Cedar Street Pump Station Rehabilitation

ADDENDUM NO. 3

July 21, 2023

2 DEMOLITION FIRST FLOOR PLAN
SCALE: 1/8" = 1'-0"
SCALE: 1/8" = 1'-0"
NORTH

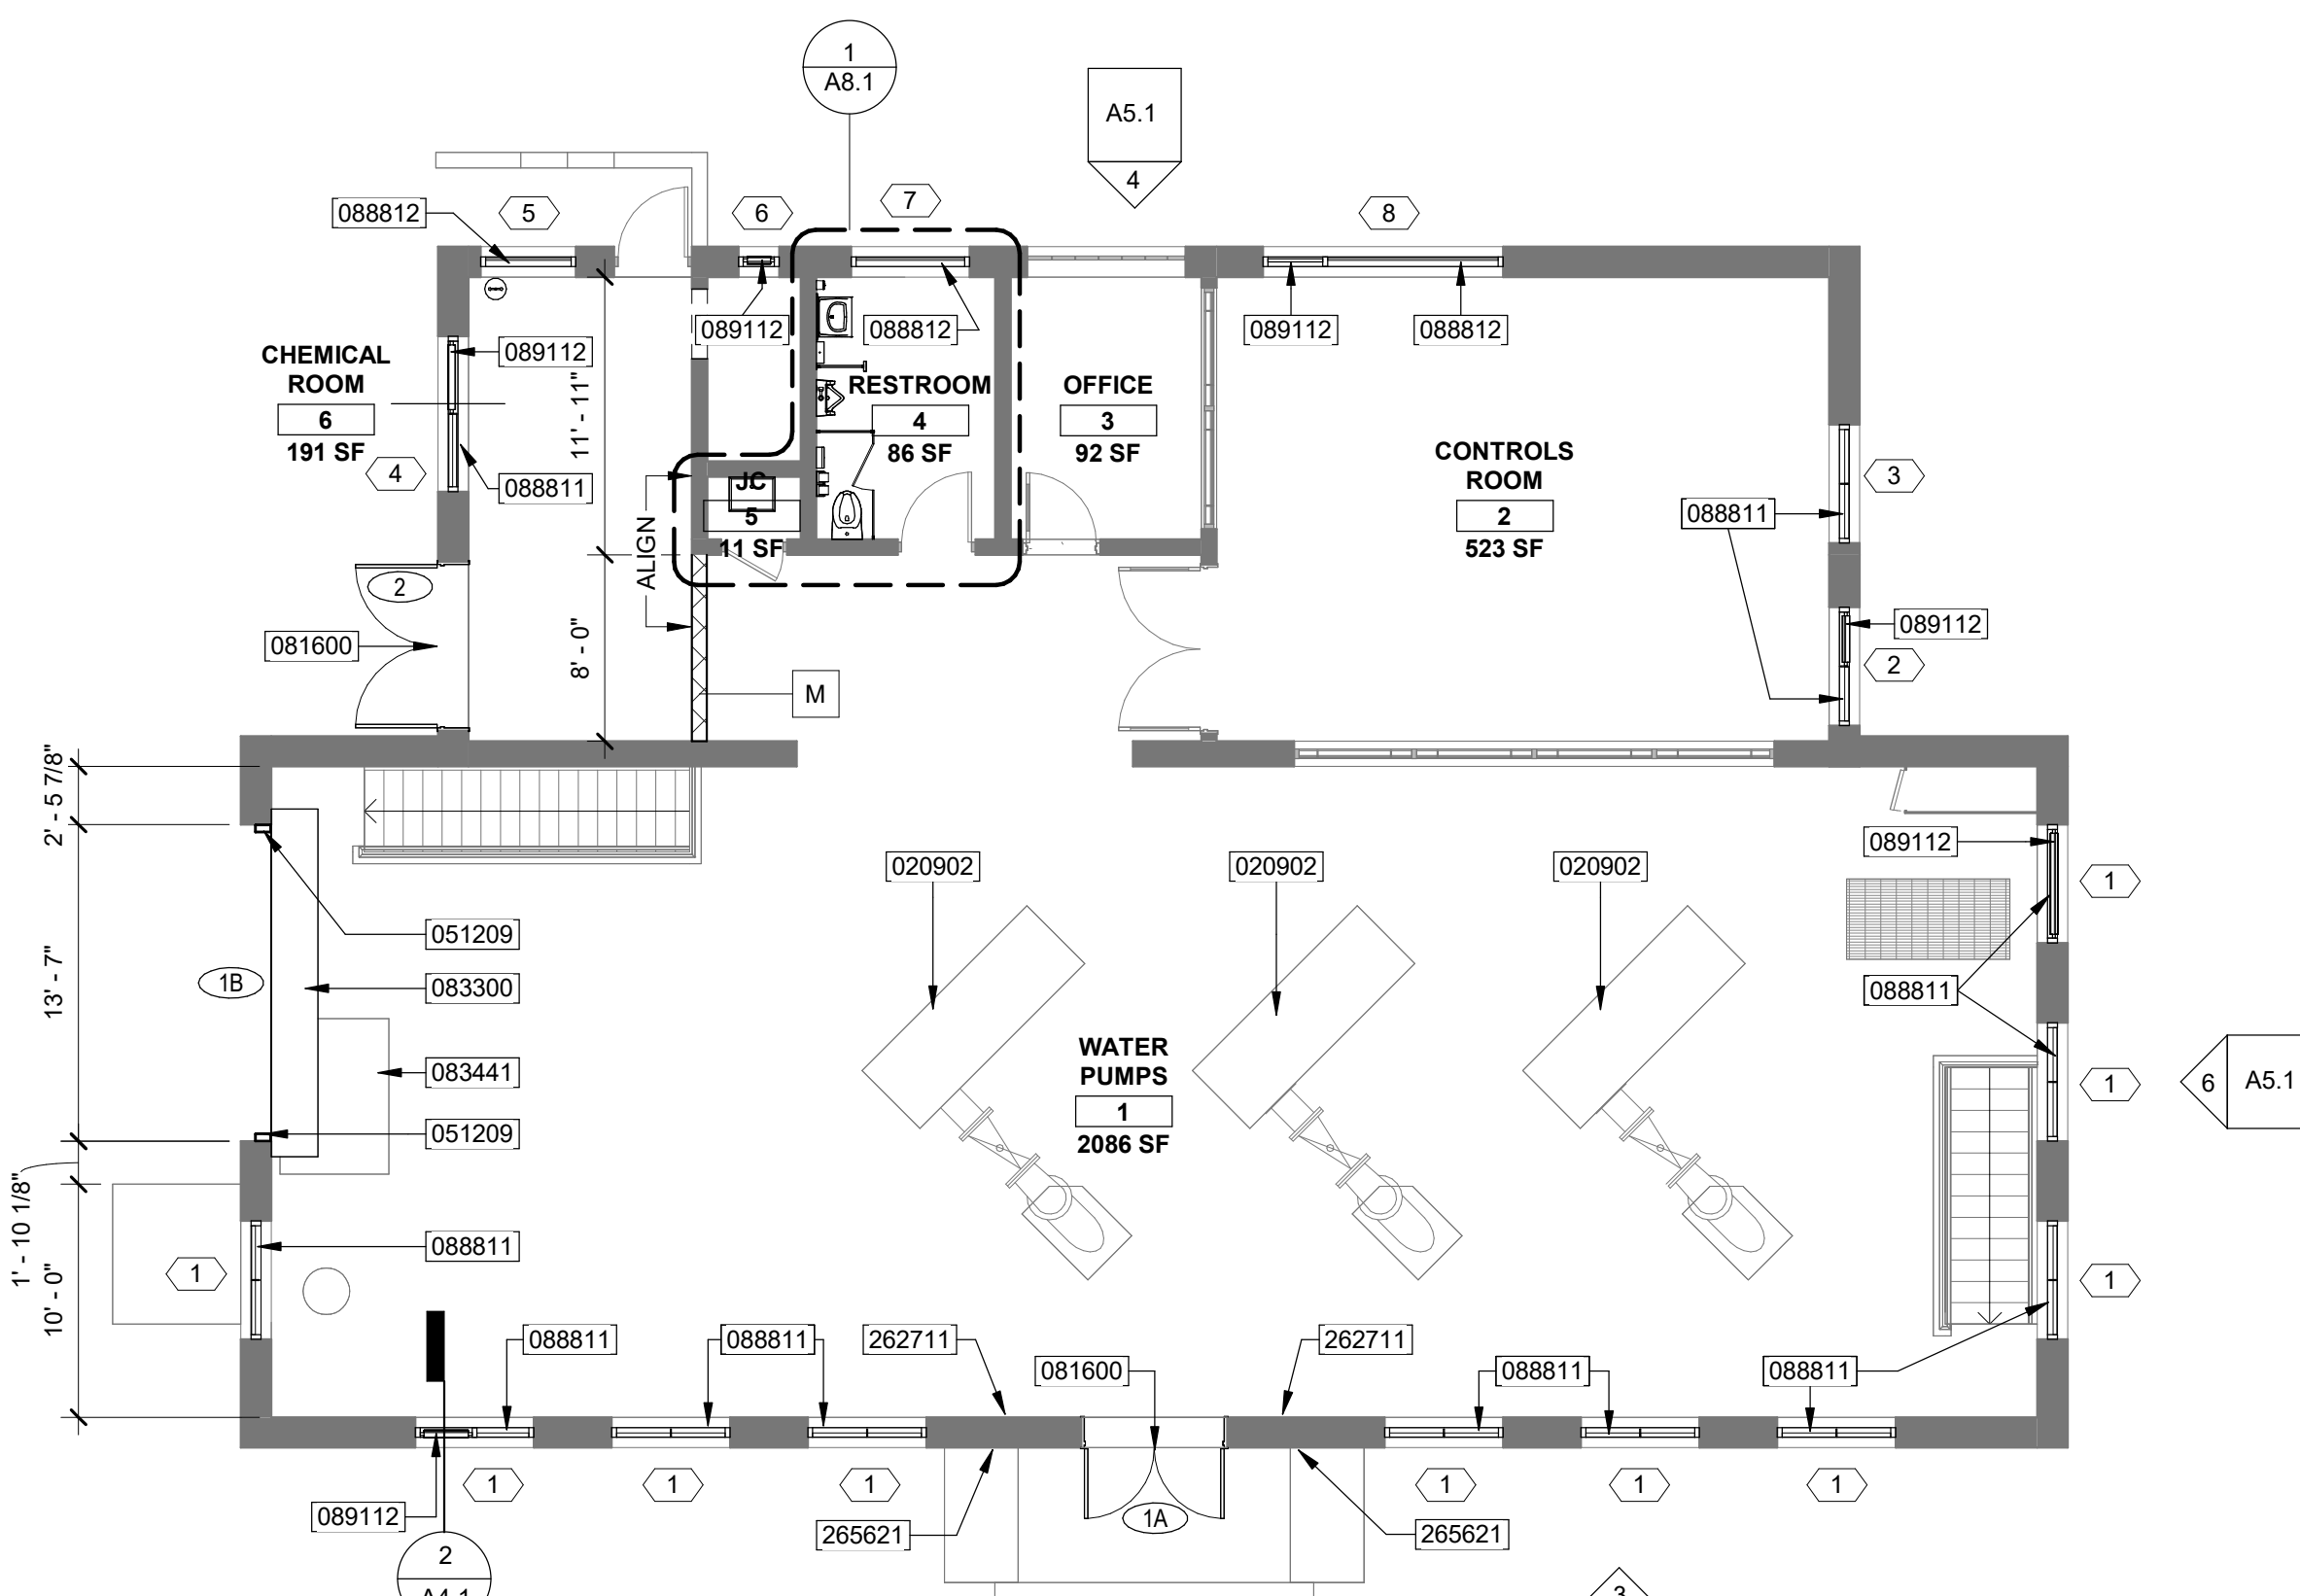
1. Keynotes 051209, 040111, 230014, 233102, and 23314 were revised to clarify work.
2. Water repellent keynote added to exterior elevations.
3. Steel lintel keynote added.
4. Tuck pointing was revised to cover the entire building instead of select areas. Total area is approximately 5,200 SF.
5. Roof repair detail for chimney removal added.
